मुंबई अग्निशमन दल

विषय: Minutes of Meeting on PEATA / MCHI Representation.

## SUB: MINUTES OF MEETING ON PEATA / MCHI REPRESENTATION

In order to streamline the procedure in issuance of CFONOC and other related issues in respect thereof series of meetings, were held from October 2023 to Jan 2024 in the chamber of Jt. MC (Improvement) when CHE(DP), CFO,EE (MCO), PEATA & MCHI representative were present. The various issues were deliberated at length & Pointwise decision taken in the meeting is as below:

# FIRE TOWER SKETCH - FOR BUILDING HEIGHT ABOVE 70MT

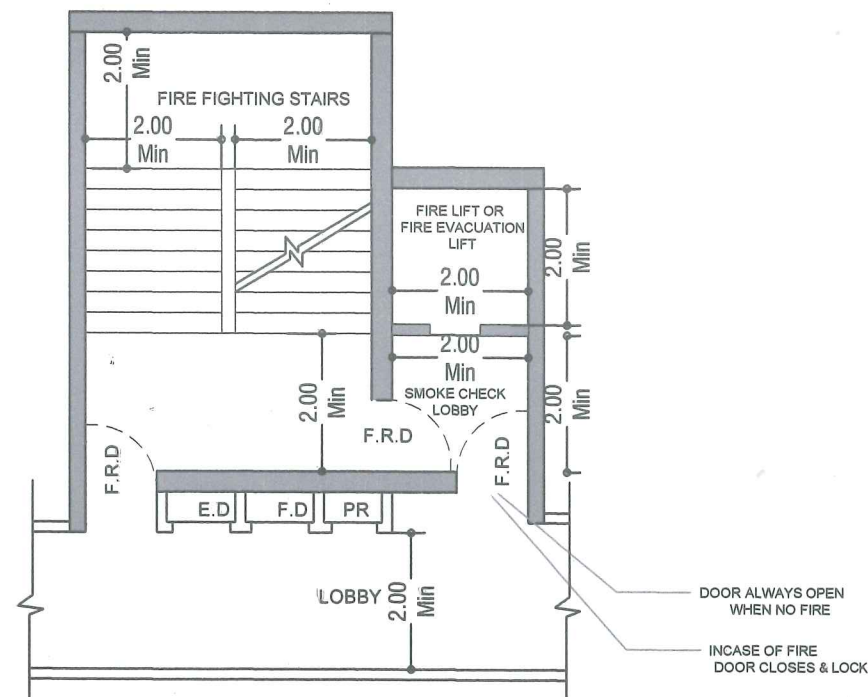
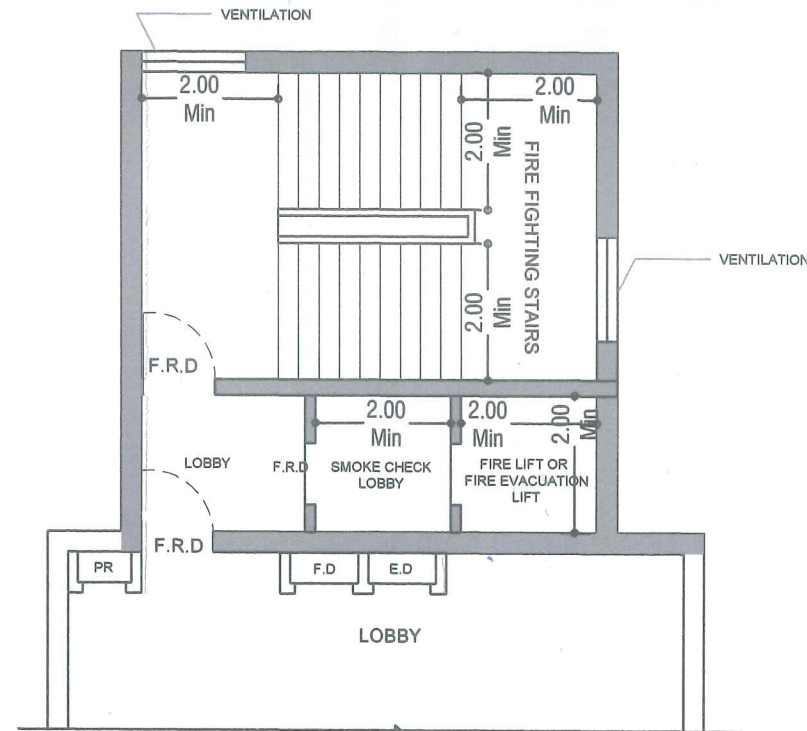
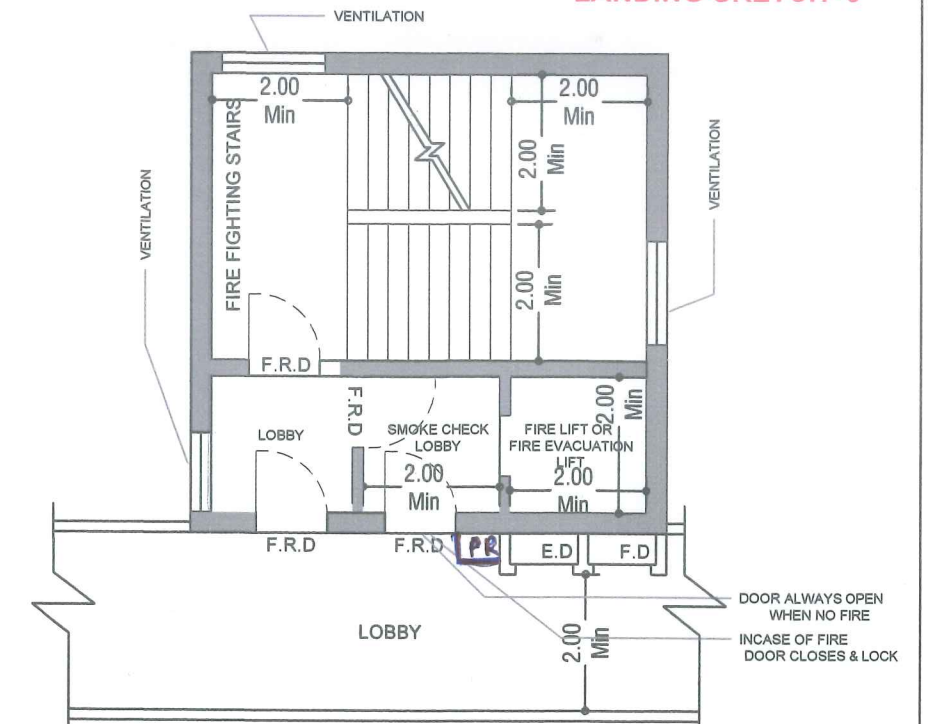
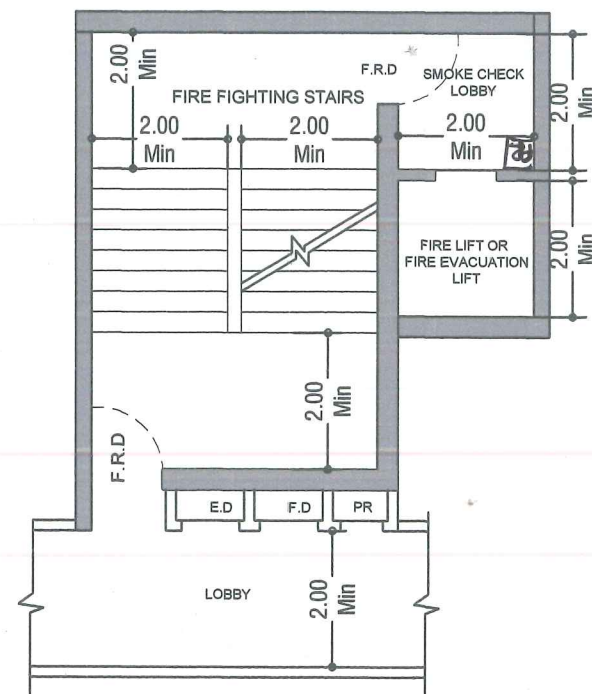
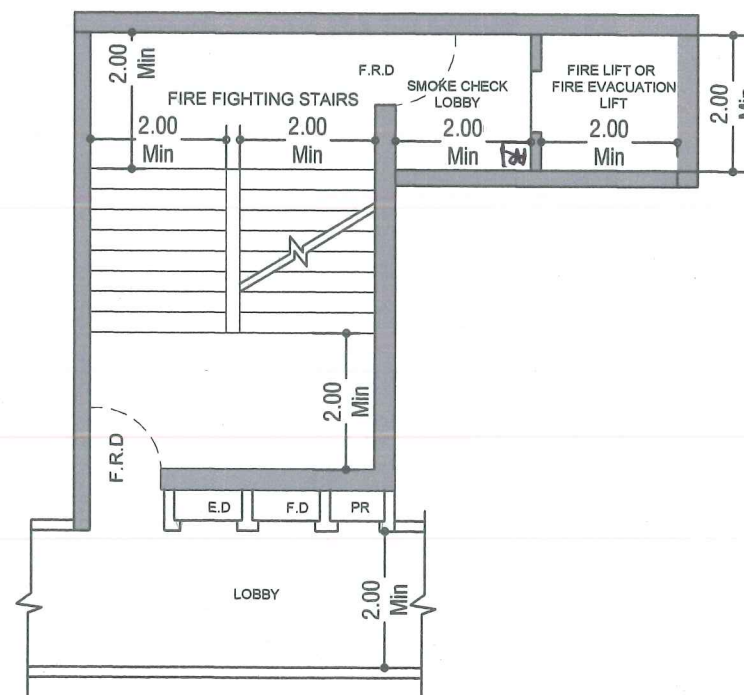
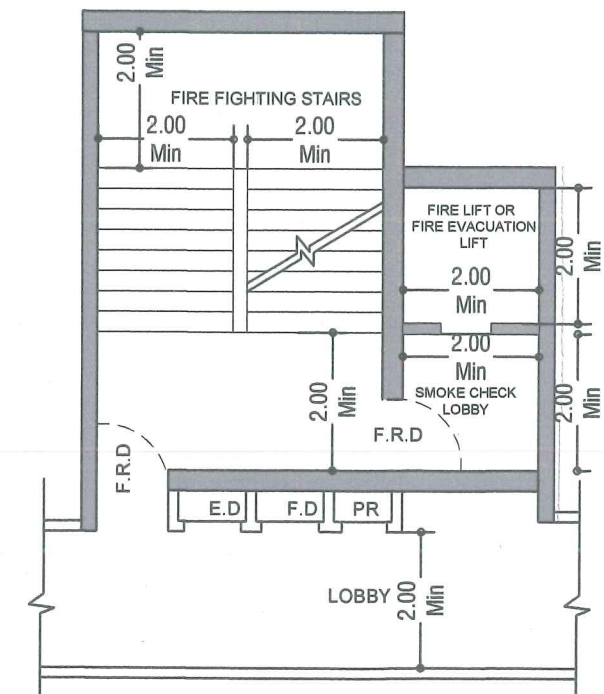
array of the sprinkler and façade should not be more than 600 mm centre to centre Distance for such sprinklers should not be less than 3.5 m (Sketch enclosed)
<b>E Fire Tower &amp; External Fire Evacuation System</b>			
12	Provision of Fire Tower & External Fire Evacuation System as Reg. 48 (9)(B) of DCPR 2034	<p>As per DCPR Regulation 48 (9) (B) two type of systems any one of which provided shall be Agreed.</p> <p>Provision of Regulation reads as below:</p> <p><i>"For High Rise Building having height more than 70m shall be provided with <b>Fire tower</b> at Landing / Mid-landing Level with Smoke Check Lobby with Firemen's Lift being integral part of the Fire Escape Staircase <u>or</u> <b>Fire Evacuation Lift</b> (Hydropneumatics' / electrically operated) on external face of the building having opening within the fire escape staircase at landing / mid-landing level with smoke check lobby as approved by CFO shall be provided.</i></p> <p><b>Fire Tower</b> if proposed shall be as per General arrangement of Fire Tower as per NBC and/or as per report of the expert Committee regarding Special Safety Regulations formulated by High Court in respect of Man made disasters.</p> <p><b>Fire Evacuation lift</b> if proposed shall be as per General arrangement and shall be as per sketches approved by CFO</p>	<p>Agreed as per sketch enclosed.</p> <p>Fire Evacuation lift of min. load capacity of 1000 kg (for fresh proposals) if proposed shall be generally as per General arrangement and it shall be as per sketches enclosed so that double redundancy for the fire evacuation lift is achieved.</p>

- NOTE- 1) STORE ROOM / SERVANT ROOM OPENING IS NOT ALLOWED IN STAIRCASE.  
 2) LAYOUT TO BE PLANNED AS PER PROJECT BASIS MEETING ABOVE REQUIREMENTS.  
 3) SMOKE CHECK LOBBY CAN BE VENTILATED OR PRESSURIZED.  
 4) SMOKE CHECK LOBBY SHALL BE 75MM ABOVE MAIN LOBBY.

WINDOW SPRINKLER DETAIL

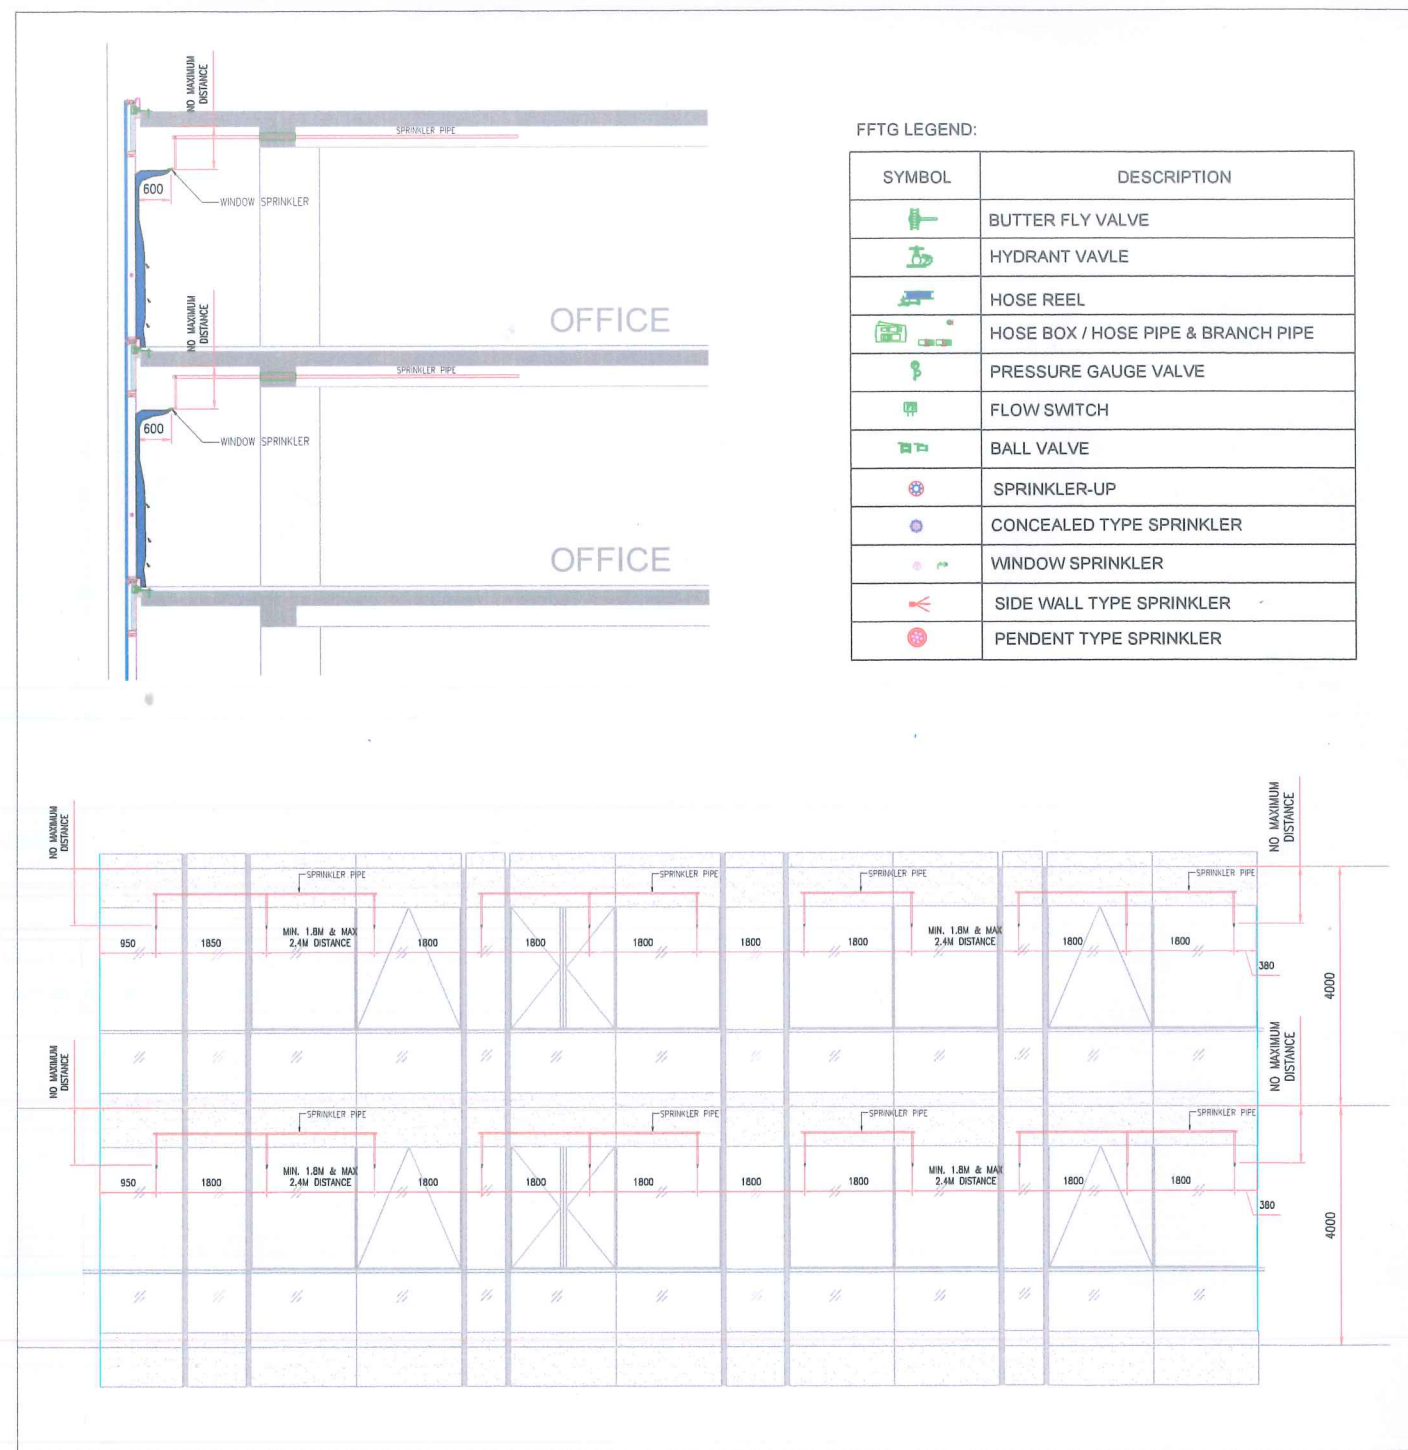
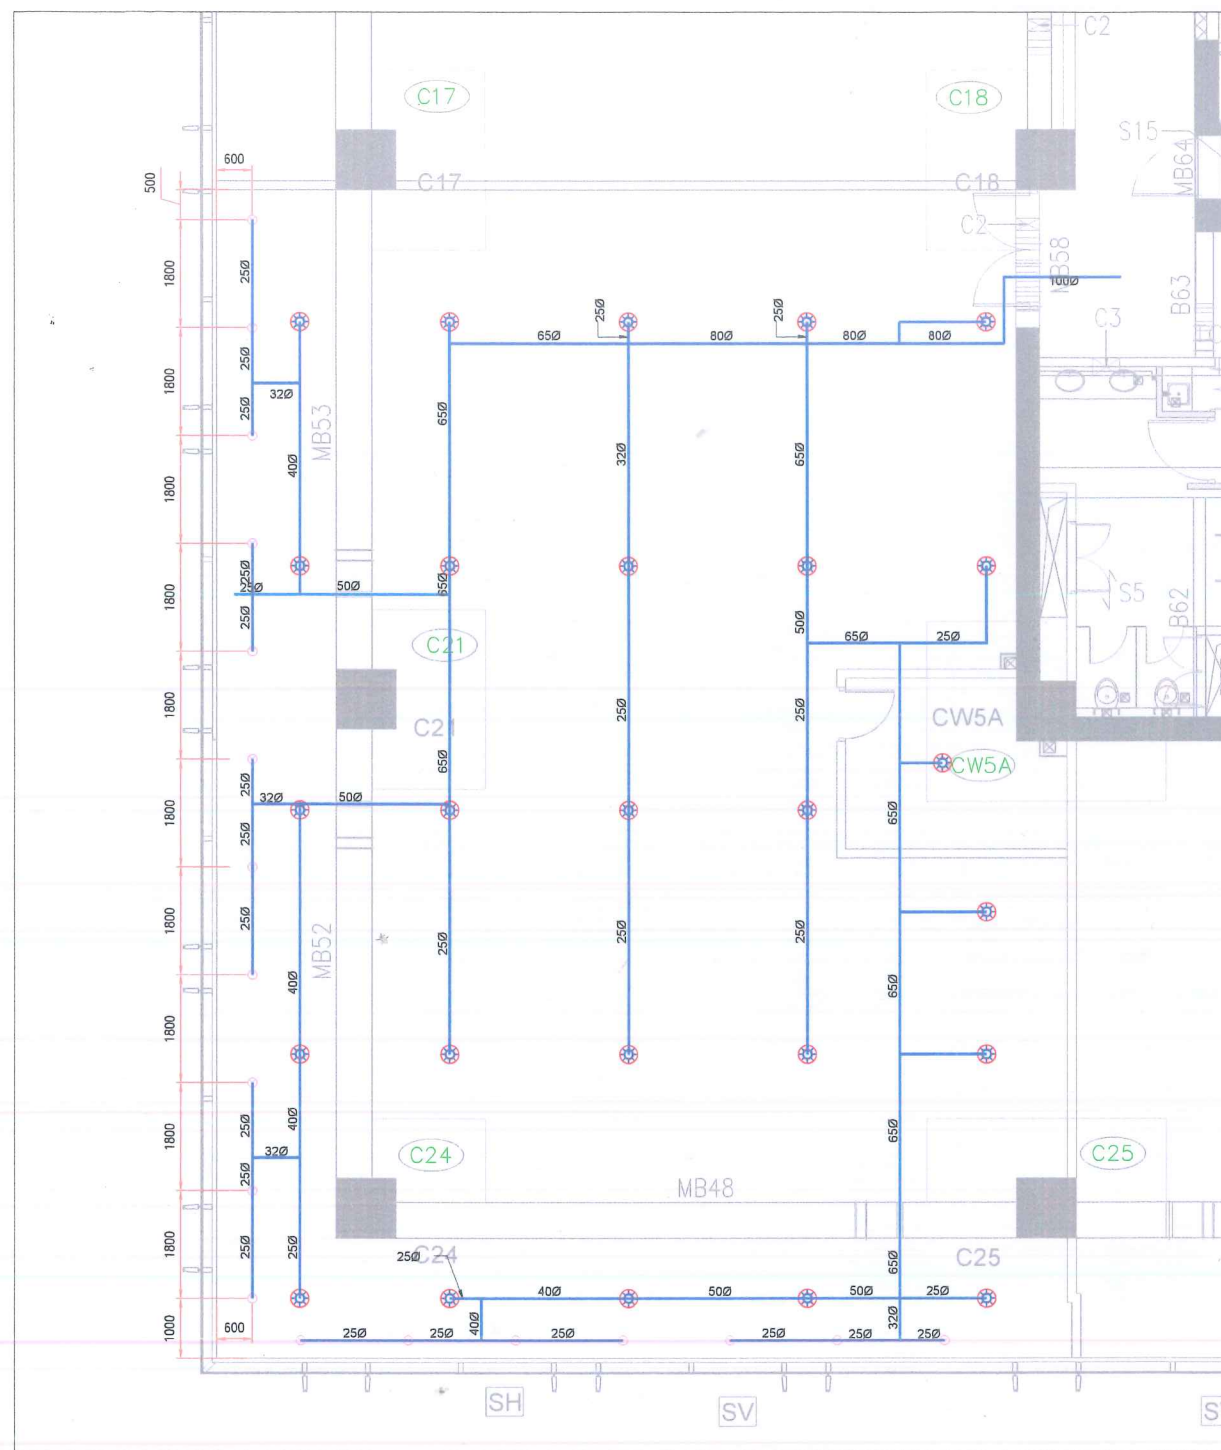
<b>D</b>	<b>Glass Façade</b>		
9	Design & Provision of Glass Façade	Glass facade details shall be as per DCPR /NBC .	Agreed with certification from MEPF consultant / Fire Safety Consultant as per NBC 2016 part 4 , clause 3.4.10.2.a in consonance with DCPR except existing glass facade buildings.
10	Provision of Sprinkler	Provision of Sprinkler at certain distance from Glass façade shall be allowed as per NBC.	Agreed
11	Provision of Drencher	Provision of drencher system is being insisted with-out giving reference to any of the code provision / NBC provision.	End of the Sprinkler arrays to be designed in a way to provide the complete linear coverage of the façade, distance between last
